Lower Hill Redevelopment
First Amendment to Preliminary Land Development Plan

Amendment to Section 1: Introduction & Section 2: Regulating Plans

Figure 7.3 Enlarged illustrative plan showing a small adjacent pavilion /restaurant with an outdoor dining terrace, pylon marking the entry plaza, and a tree-lined promenade.

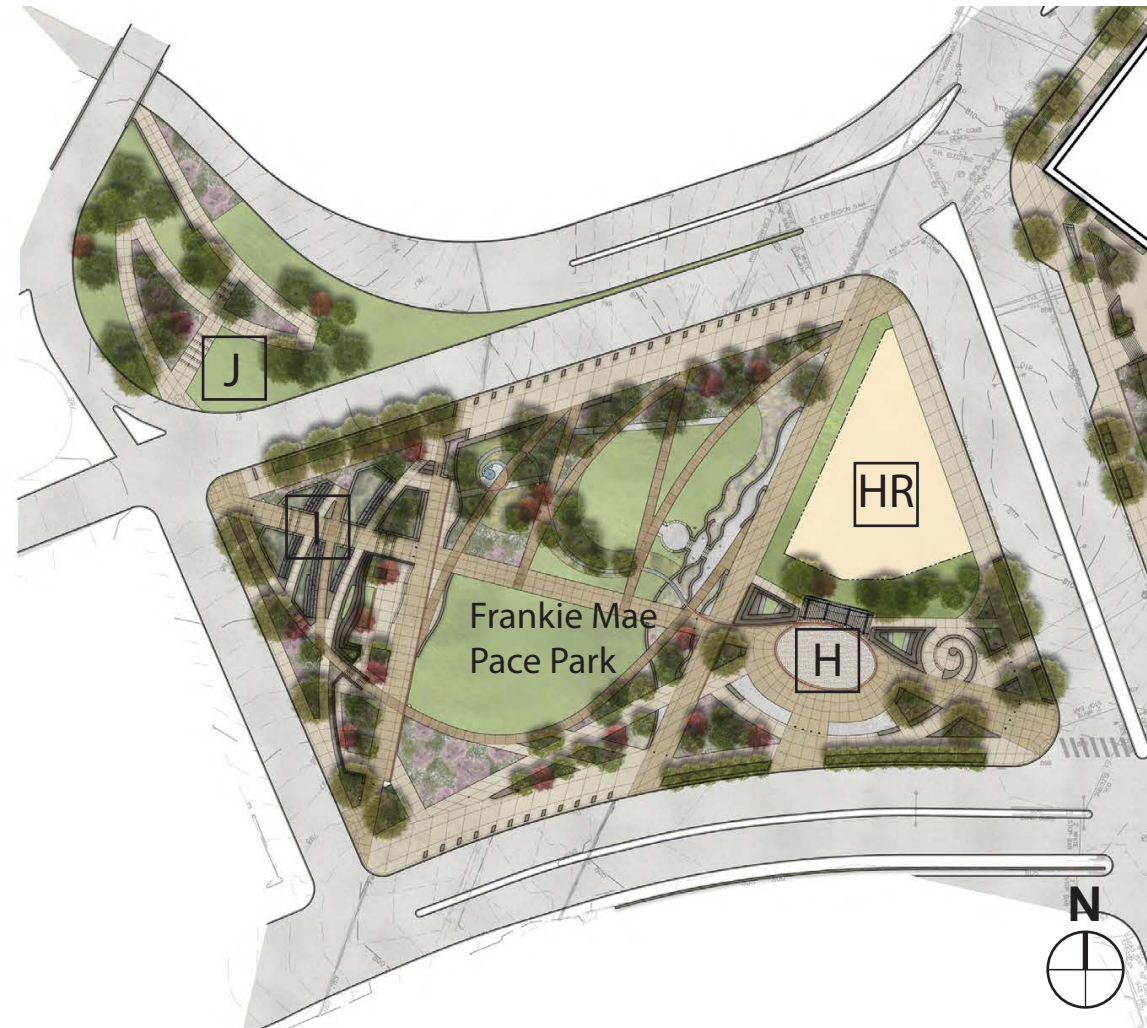
Figure 7.2 is revised to reflect the Block revisions identified in Section 2.4. and as follows: (1) Block A Urban Open Space is revised to identify Block A2 and B2 Urban Open Spaces, (2) Block F is revised to reflect the configuration of F2 Urban Open Space and F1 development parcel, (3) Block G4 Urban Open Space is added to conform to the approved FLDP, (4) Block H Urban Open Space is revised to reflect the completed Frankie Mae Pace Park.

Figures 7.3, 7.4, 7.9, and 7.16 are revised accordingly.

Figure 7.23 Plan showing potential locations of art installations.

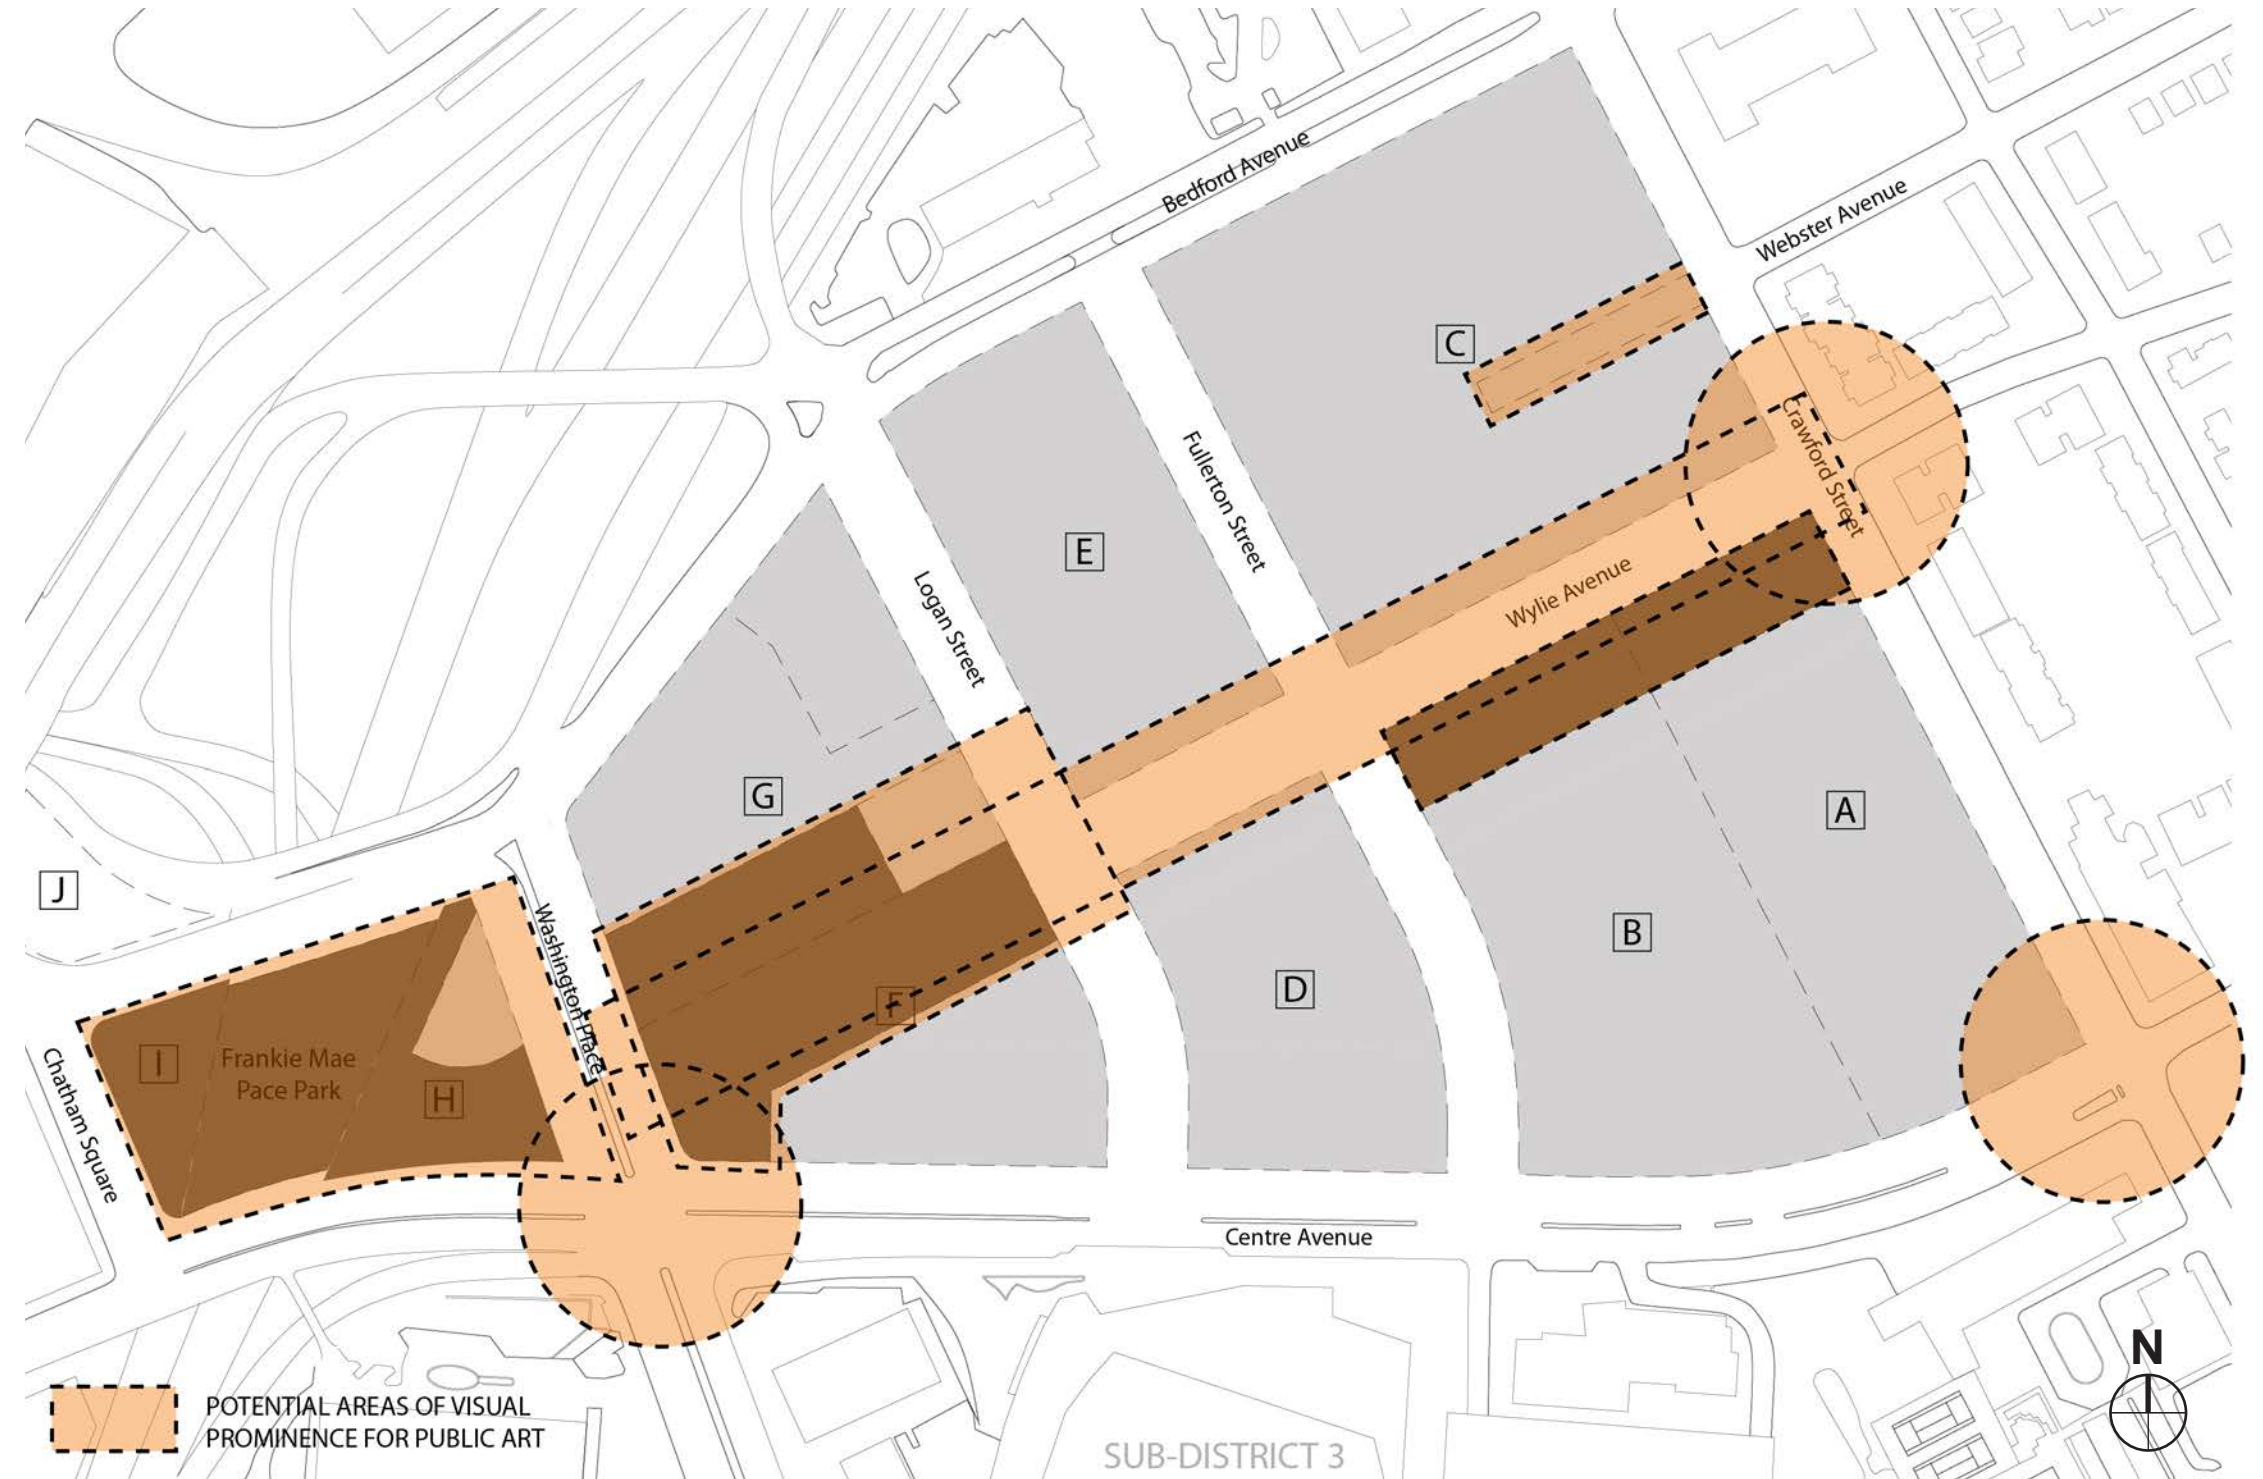
Figure 7.23 is revised to reflect the Block and Urban Open Space revisions identified in Section 7.2.
